REQUEST FOR PLANNING COMMISSION ACTION

REQUEST FOR PLANNING COMMISSION ACTION

Item Name: PUBLIC HEARING - Variance - 343 Lakeview Terrace Boulevard

Meeting Date:		July 11, 2024				
Item Name:		Site Plan & Design Review - 219 Frontage Road East				
Originating Department:		Community Development				
Presented by:		Lane Braaten				
Previous Commission Action (if any):						
Item Type (X only one):	Consent		Regular Session	X	Discussion Session

PROPOSED IMPERVIOUS AREAS

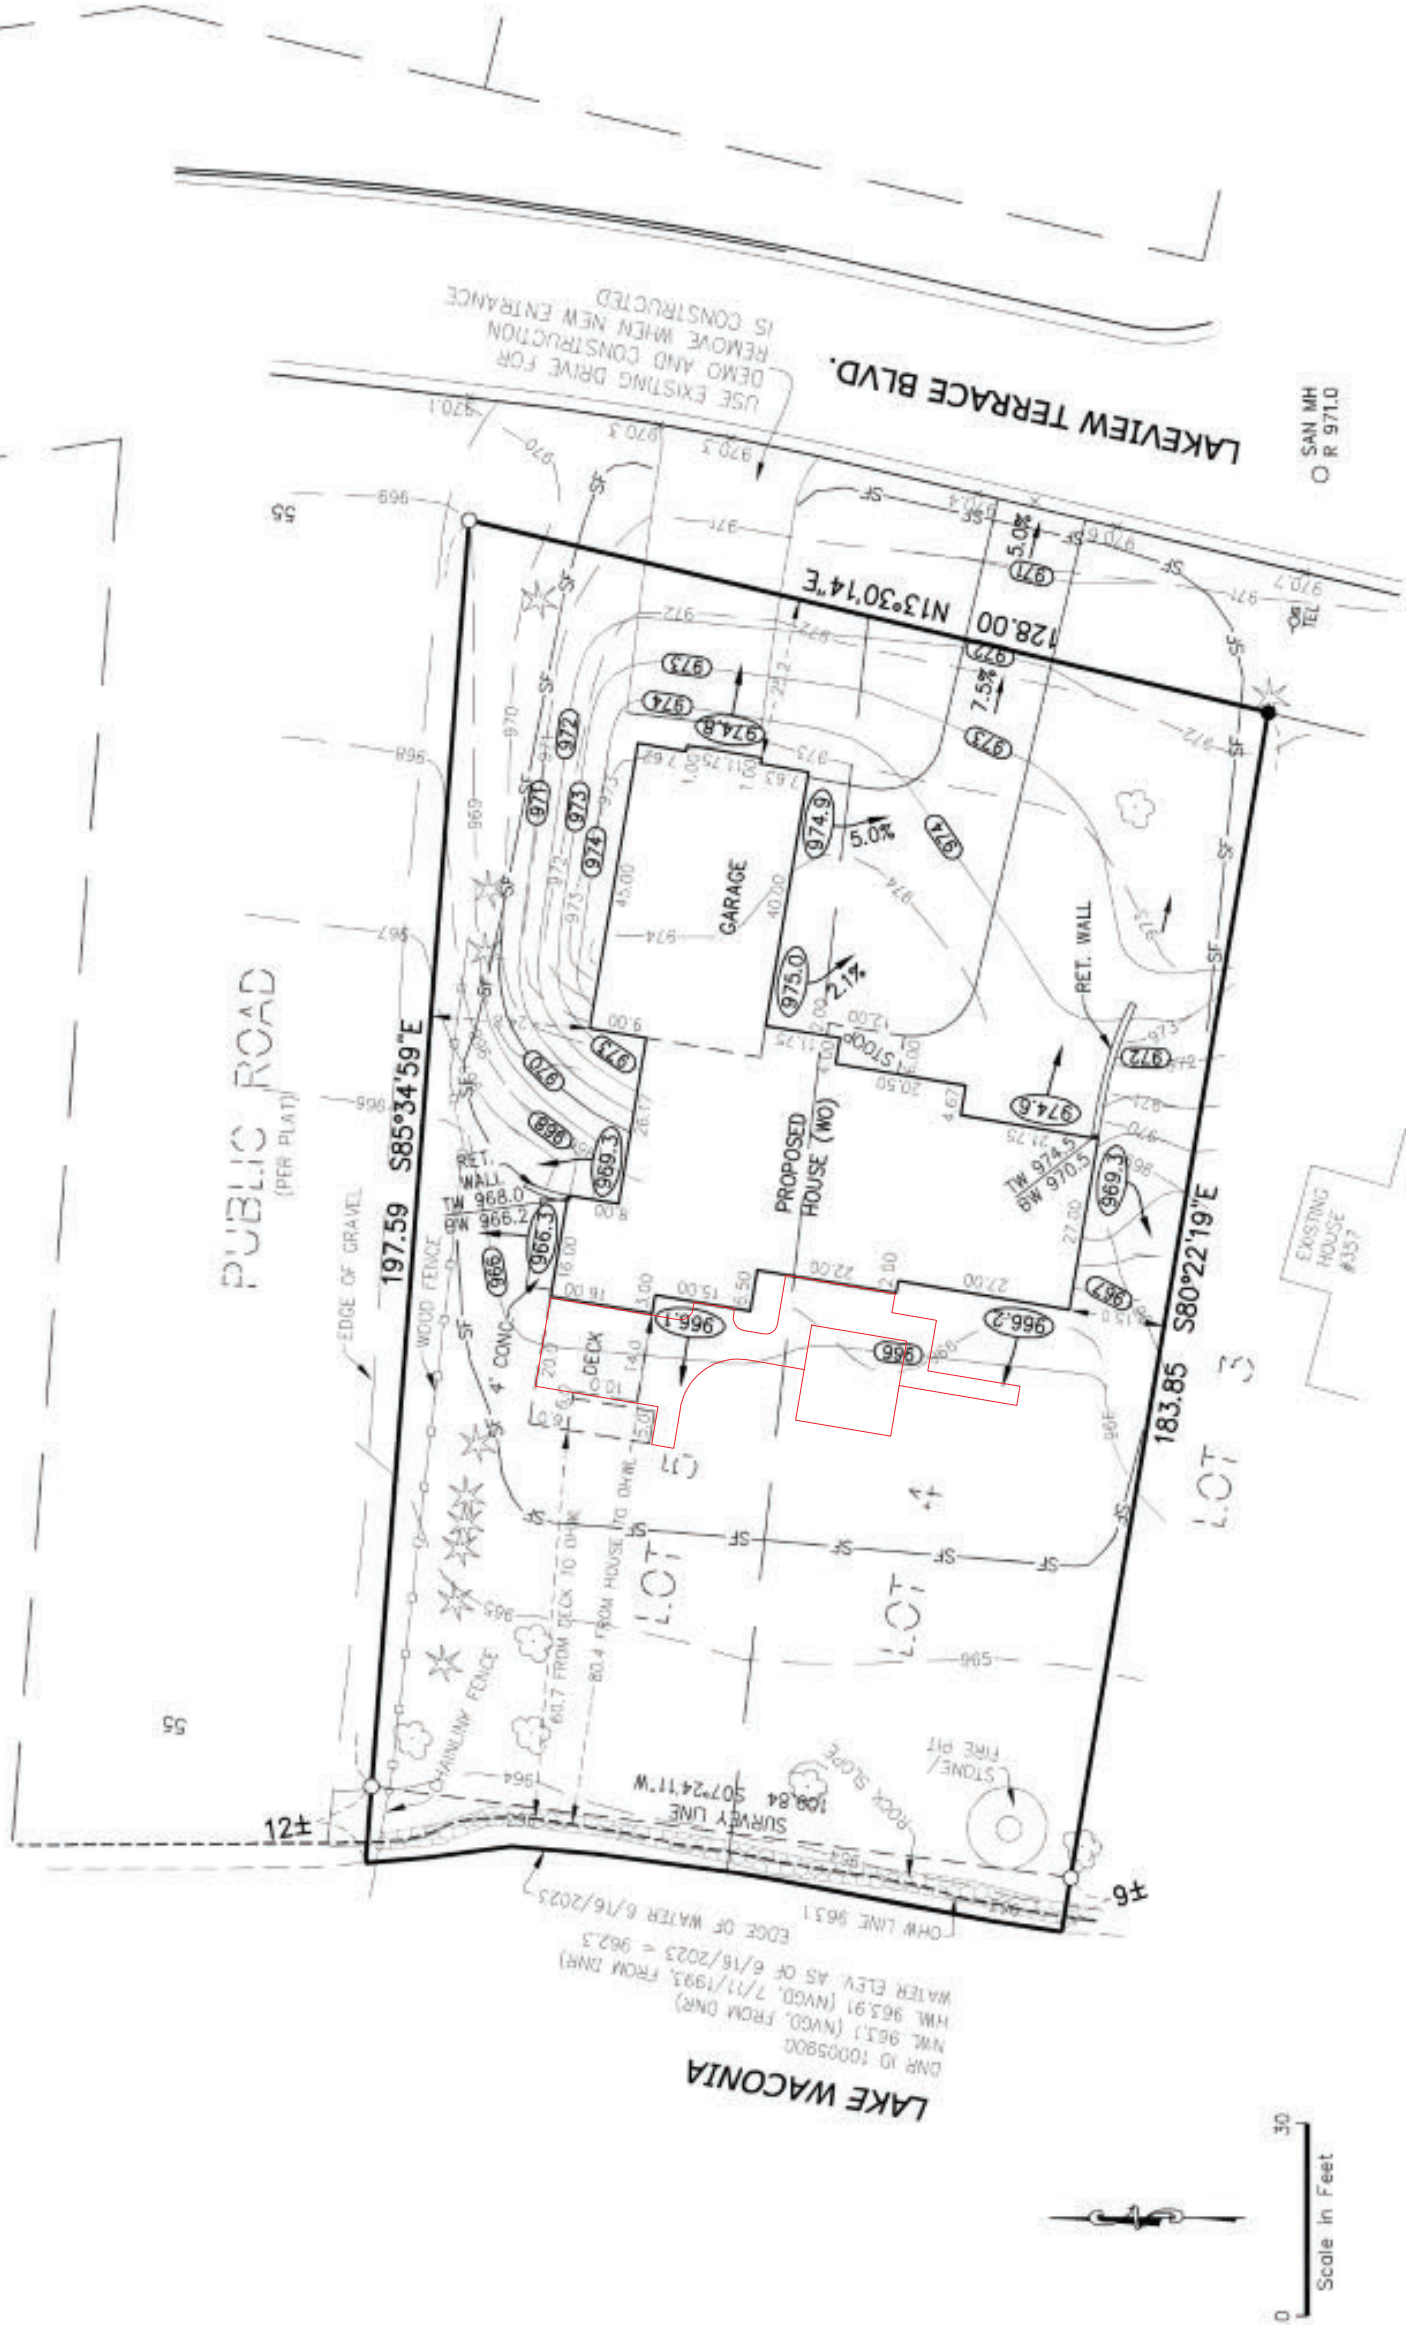
2. A stone fire pit has existed within the shore impact zone on the southwest side of the property. This was not included in the proposed hardcover calculations when the home was issued a new construction permit and is prohibited in the shore impact zone. Staff has included a condition of approval requiring the removal of the fire pit for these reasons.

5. The applicant has submitted a stormwater plan based upon City Engineer comments in the staff review that appear to generally address the comments from staff. The updated plans have been sent to the City Engineer for final review. Staff recommend requiring the final plans conform to the City Engineers approval.

1. The final Stormwater Plan shall require a maintenance agreement and be approved to the City Engineer's satisfaction. The maintenance agreement shall be recorded against the property upon execution by the property owner.
2. An As-Built survey shall be submitted to the Planning Department upon project completion detailing the following items:
 - a. Hardcover at or below 27.84%

- b. Removal of the stone firepit that is located within the shore impact zone.
 - c. Access path width to Lake Waconia shall be labeled and no greater than 20 ft.

SITE PLAN

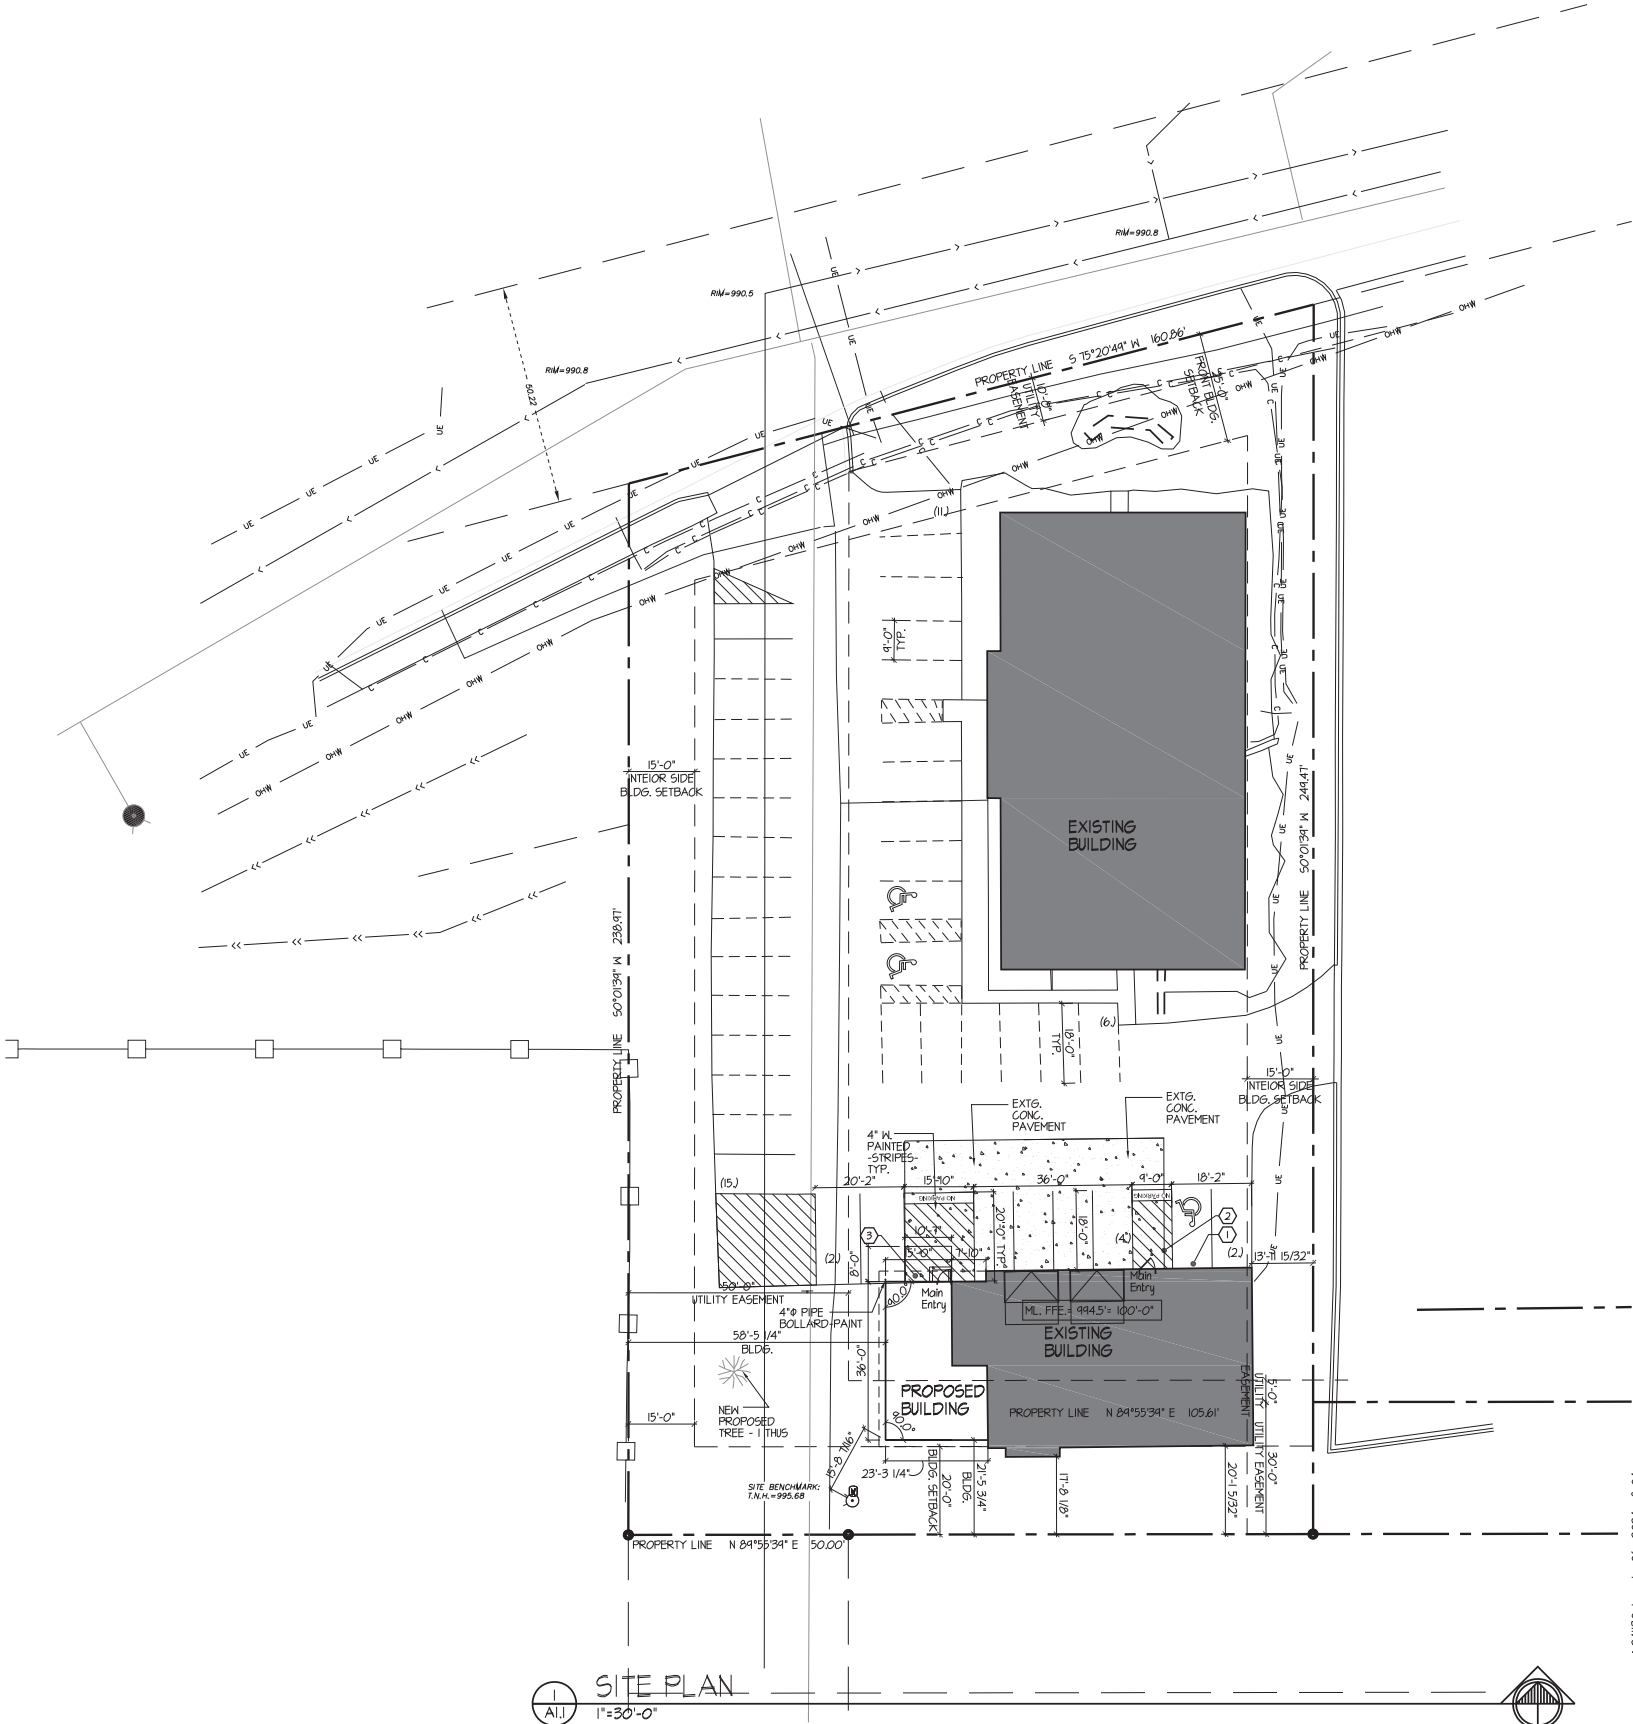
1. The current site improvements include the principal office building (4,636 sq. ft.), a secondary gym/fitness structure (2,399 sq. ft.), and improved parking surfaces. The applicant is proposing an addition to the west side of the gym/fitness building.
2. The plans indicate a 5 ft. drainage and utility easement, which is assumed to be an old rear yard easement that was left in place after the subject site acquired 30 ft. of property to the south of the original property some time ago. The drainage and utility easement should be vacated.

7. A sign permit shall be required for all signage and shall conform to Section 900.10.
8. The applicant shall vacate the existing 5-foot drainage and utility easement identified in the plan set, which bisects the existing Crusher Crossfit building and extends into the proposed addition location.

9. The property owner shall construct/stripe all forty (40) required parking spaces as identified in the approved plan set.
10. The applicant shall contact the City Planning Department for a final site inspection when all conditions of approval regarding this application have been completed.

1 NORTH ELEVATION
A3.1 1/8" = 1'-0"

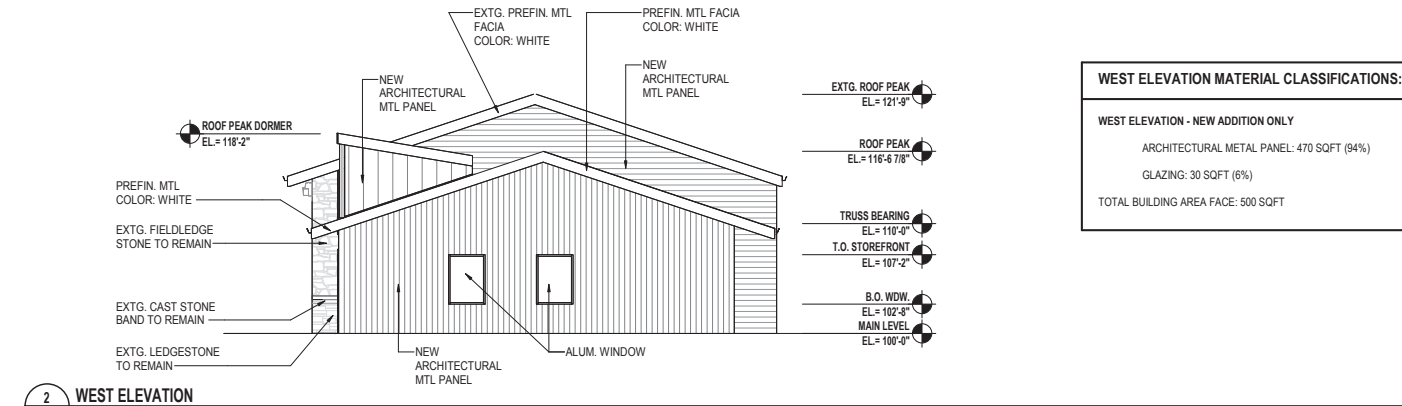
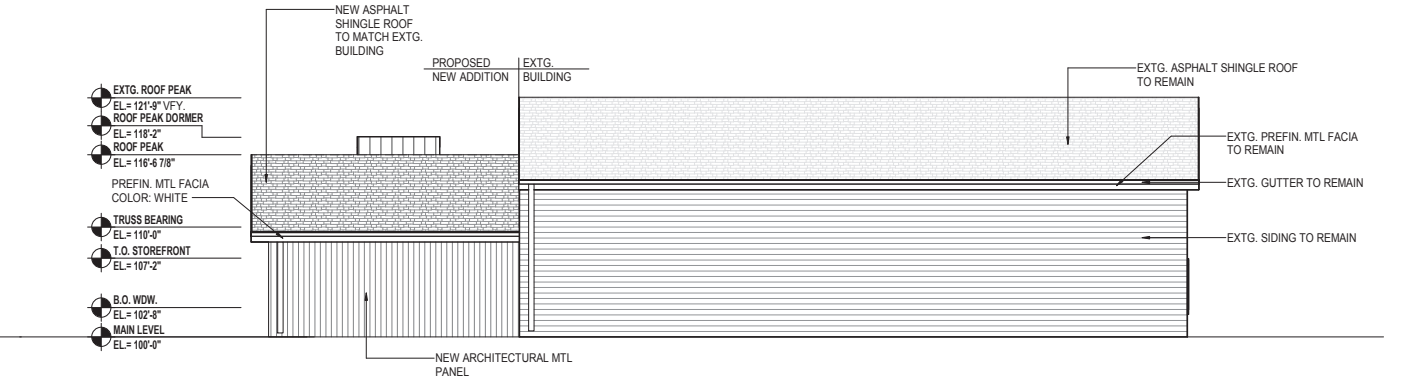
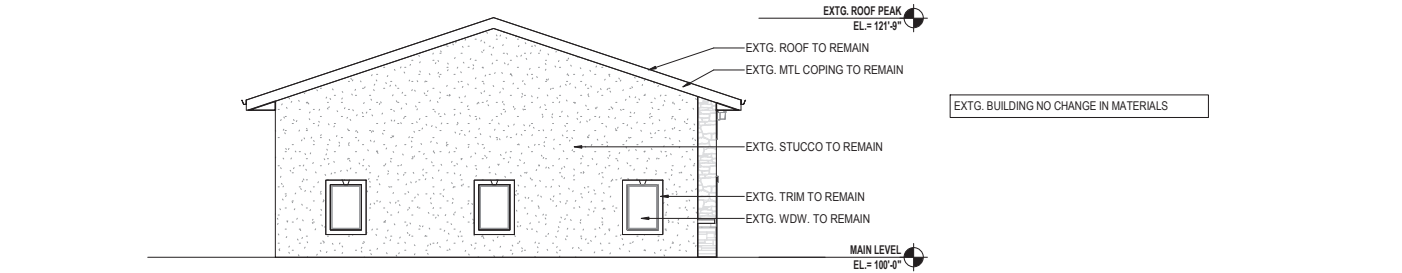
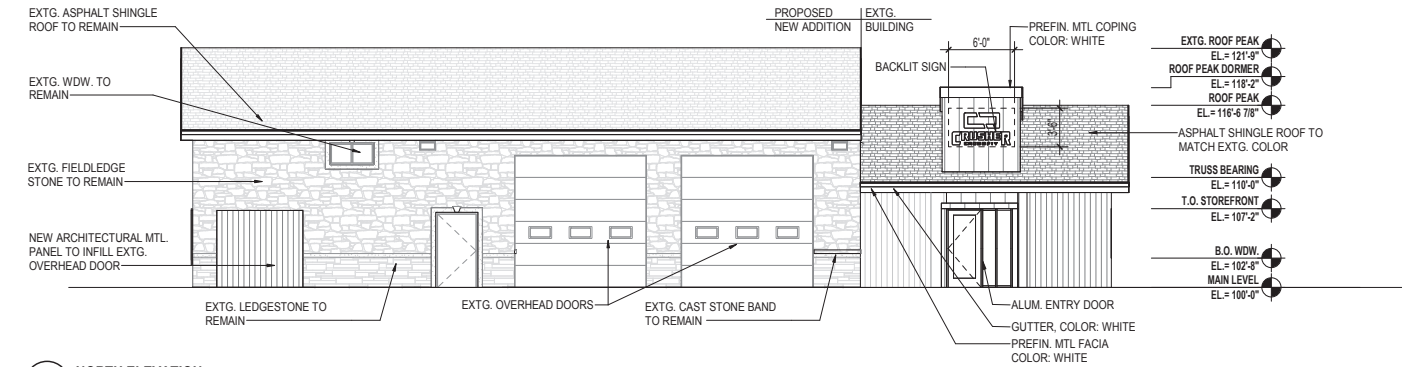
Based on a review of the plan set provided by the applicant for the Crusher Crossfit addition staff finds that the application meets the majority of the design requirements stated in the Highway Design District. The following design element requires additional review and consideration by the Planning Commission and City Council.

The proposed addition, with natural-colored metal architectural panels, conforms in both building material and color. The Planning Commission should discuss the Side and Rear Treatment design standard stated above and determine if additional improvements should be included to the existing structure to ensure continuity of materials.
